Access Compliance Report

Public Rights-of-Way

(Island Curb Cuts)

Intersection ID: 10035790	Main Street: REMOUNT_RD	Cross Street: N/A	Location: W
ADA ID: 5D380167A90E	Curb Cut Type: MedianRefuge2	Initial Pass/Fail: Fail	Overall Compliance: No
Codes/Mitigation Info/Possible Solution		Field Measurements/Component Compliance	
		Severity Score: 0

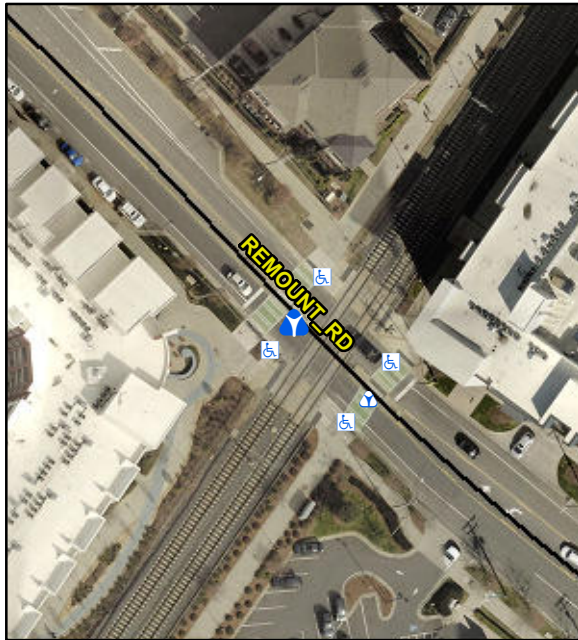
Compliance	Description	Data	Compliance	Description	Data
Yes	Refuge 1 Length (In)	40.5	N/A	Gutter 1 Ponding?	N/A
Yes	Refuge 1 Width (In)	143.0	N/A	Gutter 1 Lip Ht (In)	N/A
Yes	Refuge 1 Slope (%)	0.1	N/A	Gutter 1 Slope (%)	N/A
Yes	Refuge 1 X Slope (%)	3.1	N/A	Gutter 1 X Slope (%)	N/A
N/A	Painted X Walk1?	Yes	N/A	DWS 1 Provided?	N/A
N/A	X Walk 1 Direction	To N	N/A	DWS 1 Contrast?	N/A
N/A	X Walk 1 Width (In)	136.0	N/A	DWS 1 Length (In)	N/A
N/A	Road 1 Slope (%)	0.6	N/A	DWS 1 Full Width?	N/A
N/A	Road 1 X Slope (%)	2.4	N/A	DWS 1 Offset (In)	N/A
Yes	Refuge 2 Length (In)	40.5	N/A	Gutter 2 Ponding?	N/A
Yes	Refuge 2 Width (In)	143.0	N/A	Gutter 2 Lip Ht (In)	N/A
Yes	Refuge 2 Slope (%)	0.7	N/A	Gutter 2 Slope (%)	N/A
Yes	Refuge 2 X Slope (%)	3.4	N/A	Gutter 2 X Slope (%)	N/A
N/A	Painted X Walk2?	Yes	N/A	DWS 2 Provided?	N/A
N/A	X Walk 2 Direction	To S	N/A	DWS 2 Contrast?	N/A
N/A	X Walk 2 Width (In)	136.0	N/A	DWS 2 Length (In)	N/A

N/A	Road 2 Slope (%)	0.3	N/A	DWS 2 Full Width?	N/A
N/A	Road 2 X Slope (%)	2.6	N/A	DWS 2 Offset (In)	N/A
N/A	Refuge 3 Length (in)	N/A	N/A	Gutter 3 Ponding?	N/A
N/A	Refuge 3 Width (in)	N/A	N/A	Gutter 3 Lip Ht (in)	N/A
N/A	Refuge 3 Slope (%)	N/A	N/A	Gutter 3 Slope (%)	N/A
N/A	Refuge 3 XSlope (%)	N/A	N/A	Gutter 3 XSlope (%)	N/A
N/A	Painted X Walk3?	N/A	N/A	DWS 3 Provided?	N/A
N/A	X Walk 3 Direction	N/A	N/A	DWS 3 Contrast?	N/A
N/A	X Walk 3 Width (in)	N/A	N/A	DWS 3 Length (in)	N/A
N/A	Road 3 Slope (%)	N/A	N/A	DWS 3 Full Width?	N/A
N/A	Road 3 XSlope (%)	N/A	N/A	DWS 3 Offset (in)	N/A
Yes	Any Obstructions?	N/A	N/A	Storm Grate/Utility Hazard?	N/A
N/A	Obstruction Type		N/A	Storm Grate/Utility Type	
		N/A			N/A
N/A	Surface Condition	Good

Remove & Replace Entire Refuge.
